From:	Amadi, Eric A - DNR
Sent:	Thursday, January 24, 2019 6:46 PM
To:	'Altenbach, Lanette'
Cc:	Norman, Michele R - DNR
Subject:	RE: Two Revised Figures for Solar Paint 02-41-001051 Case Closure
Attachments:	Solar Paints_Revised Figs_for_Case_Clr24Jan2019.pdf

Residual Soil Contamination in the Unsaturated Zone
Former Solar Paint and Varnish Site
5375 South 9th Street, Milwaukee, Wisconsin

CAP Location Map
Former Solar Paint and Varnish Site
5375 South 9th Street
Milwaukee, Wisconsin

DRWN: SAE	SCALE: AS SHOWN
CHK'D: LLA	DATE: 11/20/2018
APP'D: KWB	FIGURE B.2.b

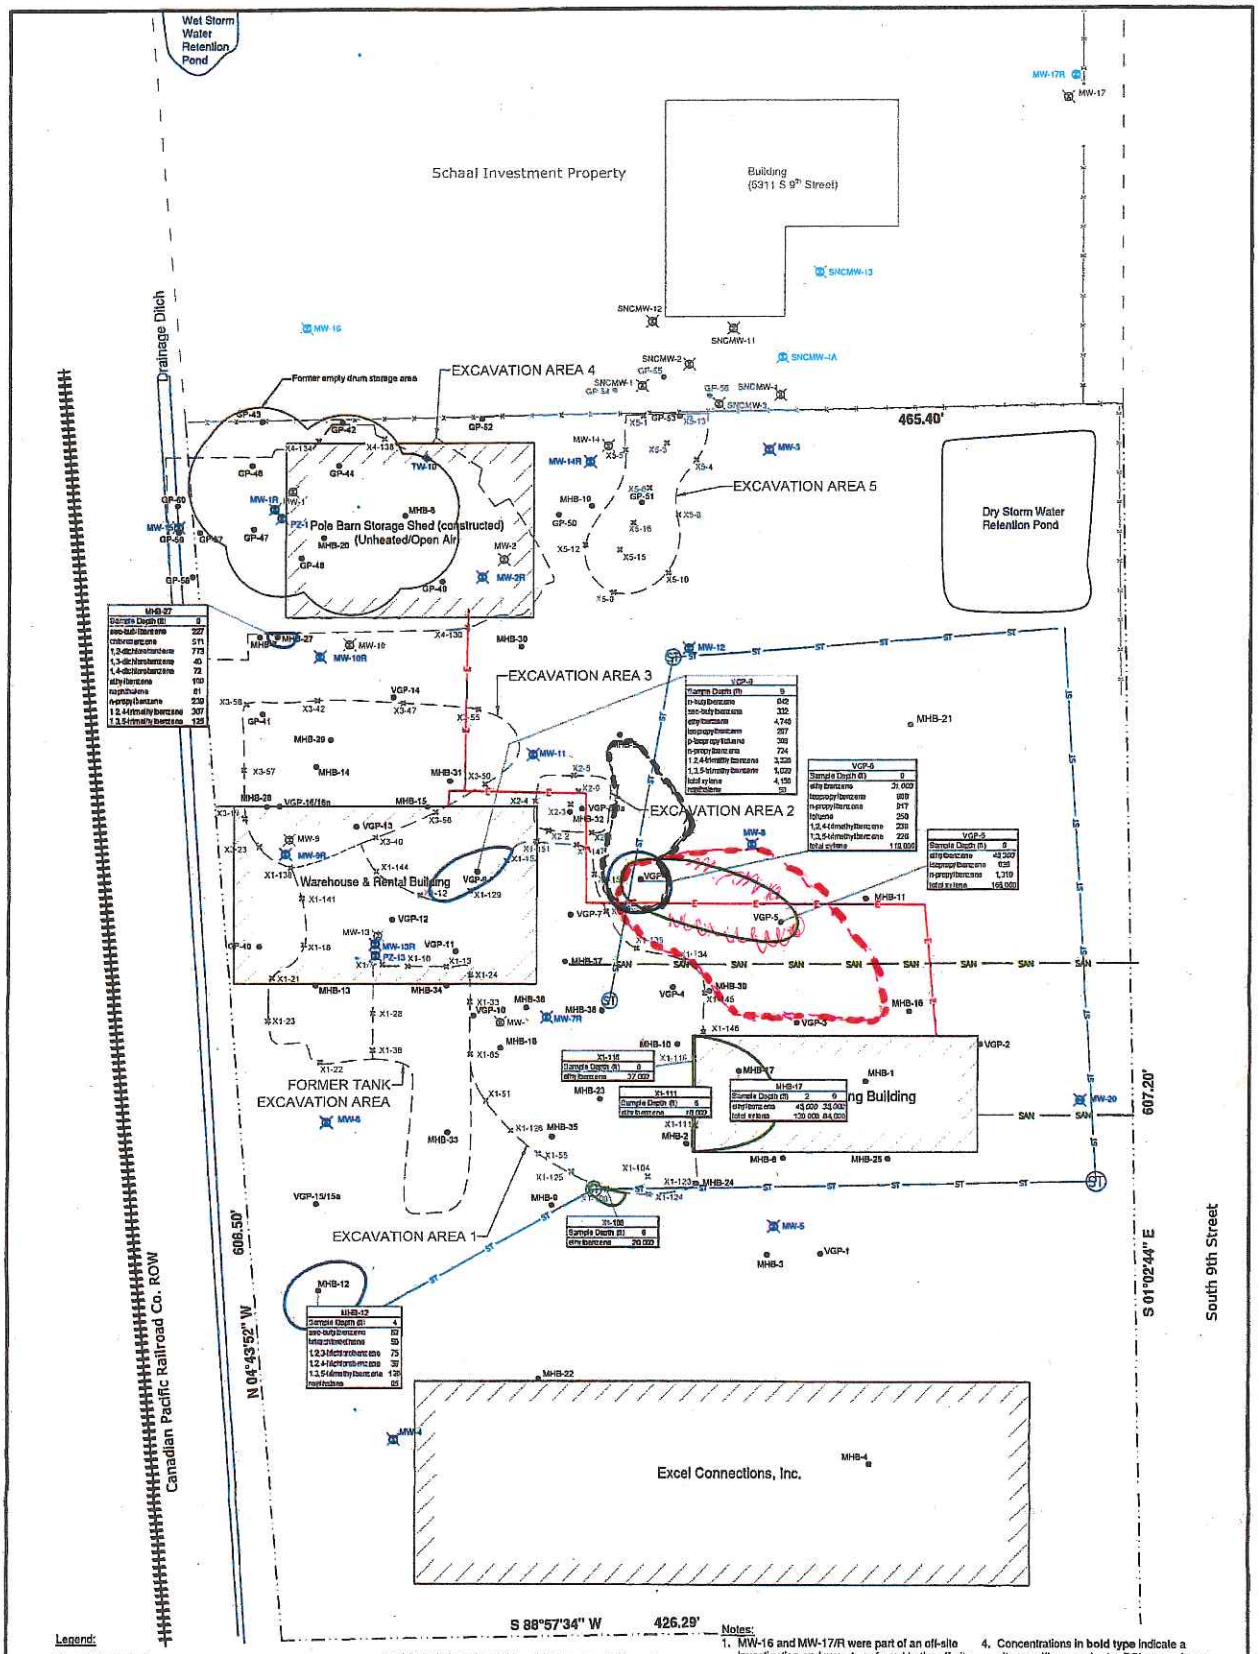
Figure B.2.b: revise the extent of residual soil contamination based on data for **all areas where residual impacts have been identified.** We suggest that residual soil impacts extent be shown in dashed lines (unless data proves otherwise

that the lines be shown in solid). For example, using data from Table A.2.b, the **dashed lines** (red - non-industrial DC) and black (GW pathway exceedances), illustrate the extent of soil exceedances in the area shown, based on data.

Revised

DRWN: SAE	SCALE: AS SHOWN
CHK'D: LLA	DATE: 11/20/2018
APP'D: KWB	FIGURE D.2

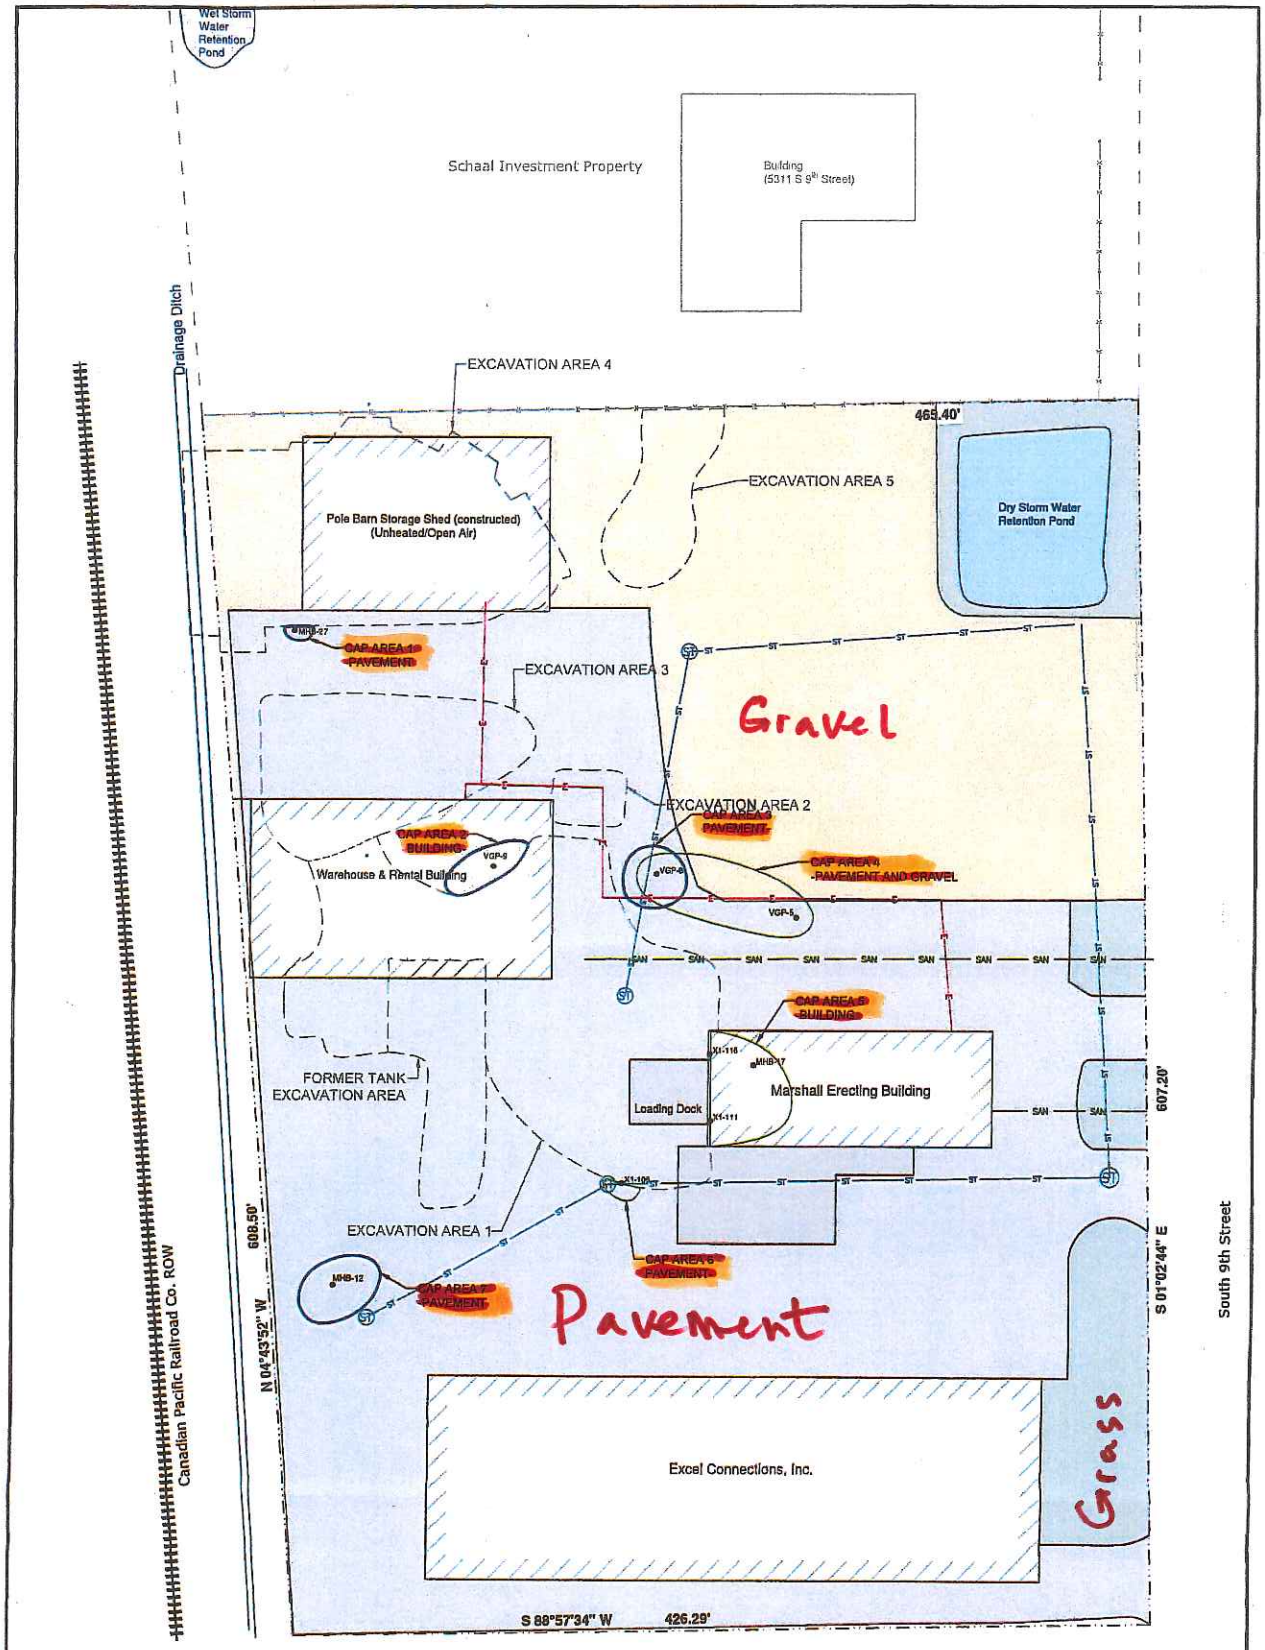
Figure D.2: revise as shown
Delete the **"cap area"** inscriptions
Label the different cap areas (pavement; Grass, etc.) in addition to those in the legend
Provide more distinct color for the legends
Use the revised extent of residual soil contamination from Figure B.2.b.

Use the revised location + extent of Soil Exceedances: Figure B.2.b
